Changes to V11.....
 SCL and SDA were switched on V10, fixed on V11
 Broke out VLOGIC line
 C2 was mislabeled as 10nF, should have been 2.2nF.
 Added selectable jumpers to CLK, FSYNC and ADO
 Minor layout changes
 Played around with IC footprint.
 Added 4 small tcream squares to middle pad.
 Rounded and elongated pads.

Sheet: /IMU/
 File: MP6050.sch

Title: MP6050 Breakout Board

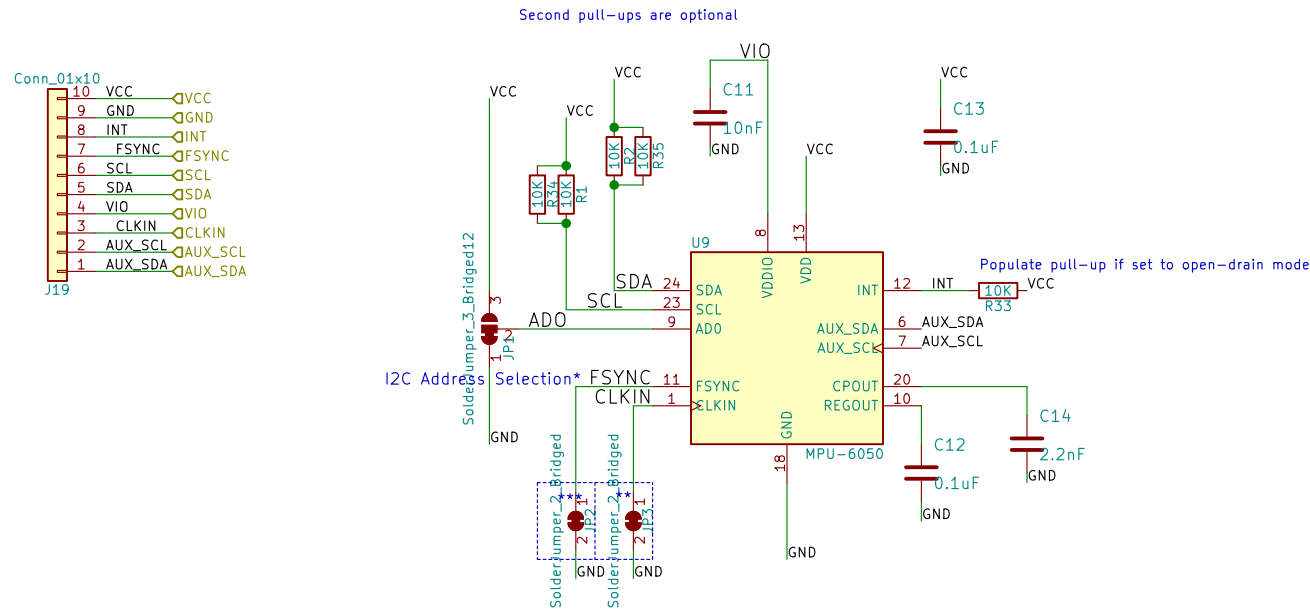
BOM changes....
 YES
 C2 is now 2.2nF instead of 10nF

Changes to V12:
 -0402 --> 0603
 -Changed Z-Axis symbol to reflect proper orientation from circle with x to circle with dot
 -Changed NET labels in schematic to flags
